Appendix 1:

Information requested under Clause 23(1) First Schedule of the Resource Management Act 1991

Planning, statutory and general matters	2
Transport matters – Martin Peake, Progressive Transport Solutions	4
Stormwater and flooding matters – Amber Tsang, Healthy Waters, Auckland Council	6
Geotech – Frank Havel, Auckland Council	18
Ecology – Nick Goldwater, Wildlands.....	19

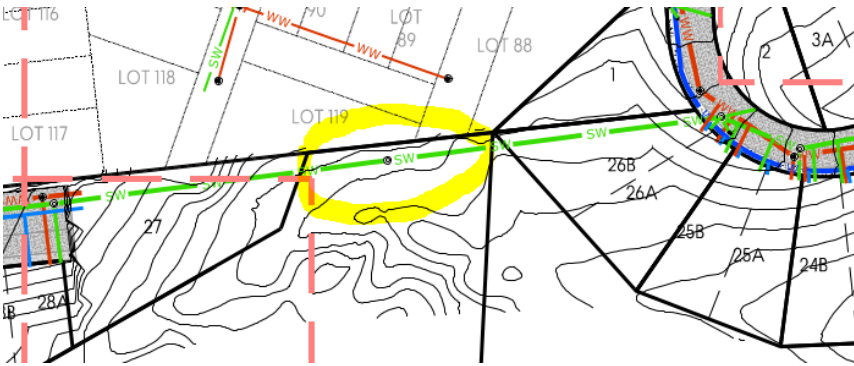
#	Information category	Further information requested	Reasons for request
		<p>How does this information differ from the actual topography considering the bulk earthworks indicated on GeoMaps's aerials photo dated 2022 (refer to snapshot below)?</p> <p>What are the current OLFP alignments across the site considering the earthworks that have been undertaken within the plan change area?</p> <p>Please update the SMP content as necessary to show current contours and OLFP.</p>
